August 8, 2023

RE: DuPont 243
 Response to May 12, 2023 Comment Letter for DuPont 243 Project
 City File Numbers: PLNG2022-031 and -032
 Our Job No. 18666

j. **Figure 1 - Tree Protection Radius within proposed grading and impervious surfaces**

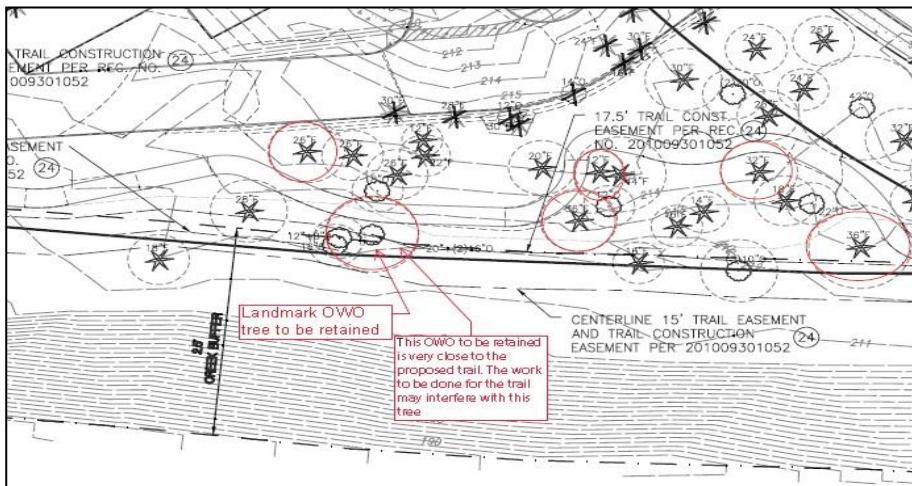
i. Sheet L2 depicts a *landmark Oregon White Oak* to be retained with its tree protection radius falling within the relocated and paved Sequalitchew Creek Trail (See Figure 1 below). It is assumed this tree is intended to be protected during trail construction, but it is not clear if the tree will survive. **WFCI shall address the tree protection measures required to save the tree in the WFCI Tree Protection Plan. Provide notes on Tree Protection Plans with the required tree protection, maintenance and monitoring measures for this landmark OWO tree.**

Response: The Tree Protection Measures section of the report has been updated to address tree protection, maintenance, and monitoring of trees for the new Sequalitchew Creek Trail.
